CABINET MEMBER FOR ENVIRONMENT – 26 MARCH 2020

OXFORD – LAMARSH ROAD – PROPOSED CONTROLLED PARKING ZONE

Report by Interim Director of Community Operations

Drawing title			
PROPOSED CONTROLLED PARKING ZONE			
Drawing Status			
Scale @ A3	Drawn by	Checked by	Approved by
N.T.S.	Date drawn	Date checked	Date approved
Oxfordshire Project No. & File Ref

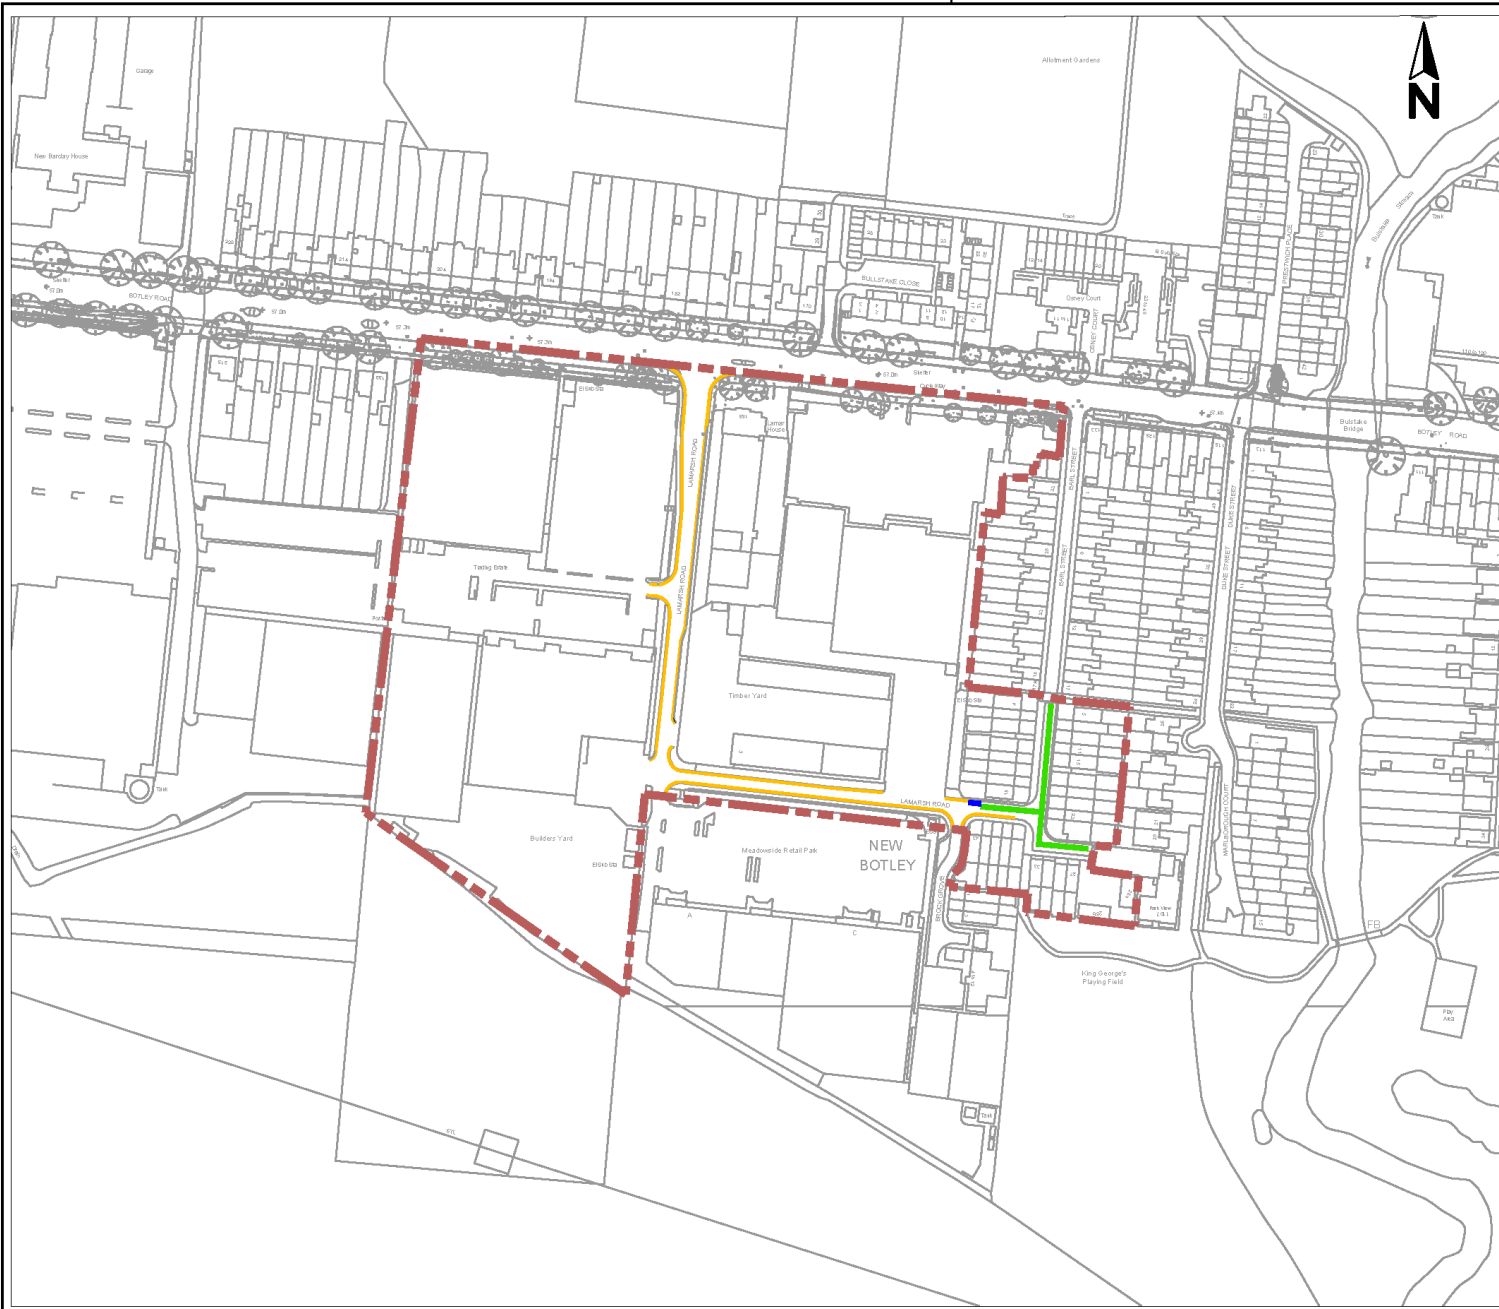
<p>It is impossible to tell from the maps however whether the parking bays will be on road or if they will take incorporate space over pavements as has happened in other CPZ areas in the city. If any of the plans actively encourage car drivers to park on - and therefore drive on - pavements – this is unacceptable and we would place an objection. There can be no justification for taking away space from pedestrians, including for example young children on balance bikes, parents with buggies, or people in wheel chairs or mobility scooters, and handing it over for the parking for private cars. There is no need on quiet residential roads to have space to allow two large vehicles to pass if that is at the expense of pavement width. Other better alternatives are providing space for car parking on one side of the road only, or allowing some car parking at a 45 degree angle on one side of the road - even this would be better than legitimising pavement parking, and should at least be considered.</p> <p>Whilst the present plans will discourage car use by people from outside the area, perversely they may encourage car use by local people; permits should be restricted to 1 car per household, and the number of parking spaces limited, especially by limiting parking to only one side of the road at a time, which in many streets is all there is space to do safely. As we face a climate emergency we want to see policies that encourage people to give up private cars and use alternative transport with all its benefits for health, environment, congestion and the economy.</p>

There is insufficient information from your plans to indicate what is likely to happen. The proposal is clumsy and overly restrictive on residents for what is a non problem. Occasionally there are non-resident cars parked in the road but not in a way that caused a problem.

It is not clear where in the road cars with permits will be able to park. Marked bays or not? Most of the spaces in the road block drives. Some visitors park on the pavements across drives as do residents. This causes no impact on other road users but maybe disallowed by this scheme. What will be allowed and what won't? What would need a permit?

Parking Restrictions – **Object** – The yellow lines up to Brock Grove should not extend all the way to the new car club parking bay (which you seem to have already marked out despite this only being a consultation). The yellow lines should extend no further than is necessary beyond the narrowing in the road. No further than is necessary to allow emergency vehicles through.

I would also ask that there are yellow lines on the section opposite the entrance to the properties 25a and 25b, that is Dyl round side of 25, across two entrances and continuing a bit further than the Kerb drop (/rise, in that direction). Getting into this courtyard is incredibly difficult if vehicles park opposite the entrance or right up to it.

<p>(21) Local Resident, (Oxford)</p>	<p>CPZ - Object - Most of the residents in Lamarsh Road have their own driveways to park their cars. In this context, it does not appear that the green line as marked on the map makes much sense as there are so many driveways. The green line appears to suggest the blocking of access to people's driveways, which I am sure cannot be the case.</p> <p>Parking Restrictions - Neither - I would like consideration of double yellow lines between 8 - 10 Lamarsh Road and 15 - 17 Lamarsh Road, as people park on the pavements and block access to the alleyways between both sets of houses.</p>
<p>(22) Local Resident, (Oxford)</p>	<p>CPZ - Object - I'm writing to you as a house owner from Lamarsh Road about the new controlled parking proposal for Lamarsh Road. When Susanna Pressel came to our door to ask about our opinion of the 2018 CPZ proposal, for parking permits on the road, we expressed that it would be good for all existing households to be granted permits with additional guest parking permit passes. This would minimize residents from other nearby roads such as Earl Street and Brook Grove taking parking spaces from Lamarsh Households. Upon this premise we agreed that controlled parking zones would be beneficial for home-owners here.</p> <p>When parking permit plans were published a week or so later, the proposal was quite different to the one that we had discussed with Susanne. None of the existing households of Lamarsh Road with driveways would have rights to park on the road. We find this proposal would stop basic living freedoms of allowing guests to visit whilst taking away the option of having a second car. This proposal imposes on daily living and creates commuting difficulties, mostly for people who drive outside the city to get to work.</p>

13. The objections relating to the proposed waiting restrictions are similarly noted. It should be stressed that the actual changes to what are currently in place is limited to a small length of the north side of the road near the junction with Brock Grove to help ensure that access to and from this road is not obstructed.

14. The consultation also included provision of a Car Club bay near the junction with Brock Grove. If approved, this bay would, however, only be implemented if a Car Club operator confirms that they wish to provide a car for this site.
